World Forum for Harmonization of Vehicle Regulations

Working Party on Passive Safety

Regulation No. 80 (Strength of seats and their anchorages (buses))**Proposal for Supplement 1 to the 02 series of amendments to
Regulation No. 80****Submitted by the experts from Belgium and Germany***

Figure 1: Positioning requirements for side-facing seats

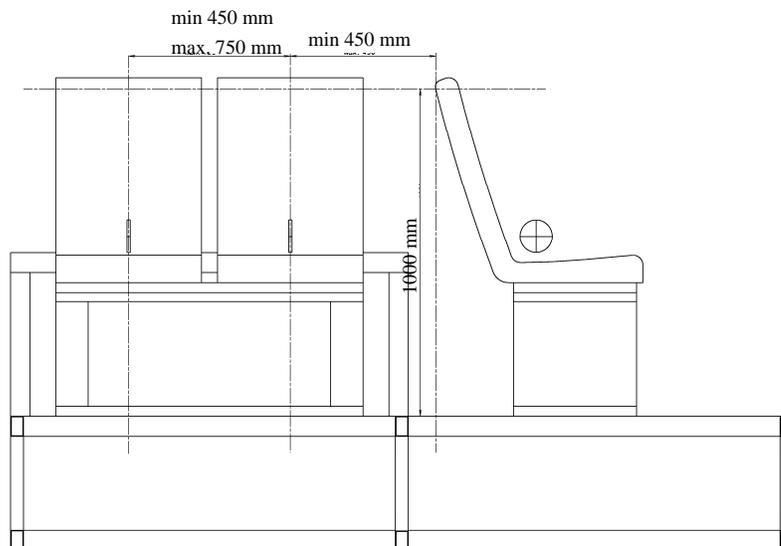
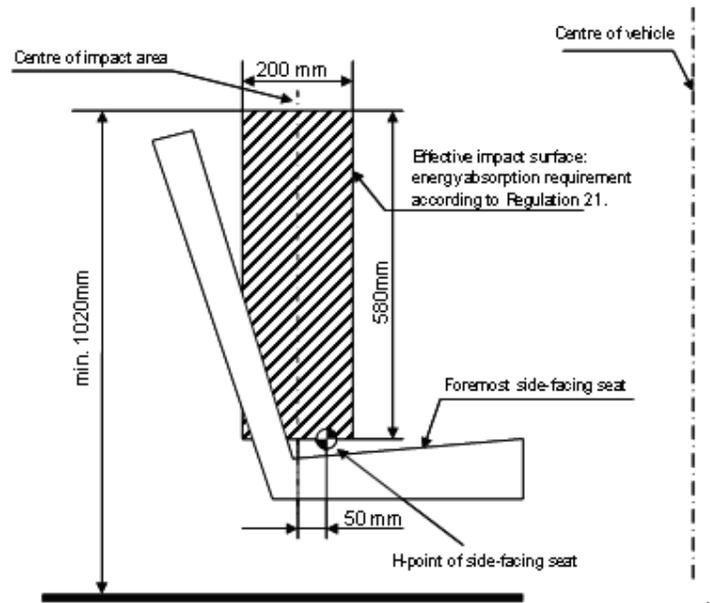
1. The distance between the foremost side-facing seat and the vehicle part forward of this foremost side-facing seat shall not exceed 450 mm. All measurements are to be taken 1000 mm above the foot contact area of the foremost side-facing seat (see Figure 1).
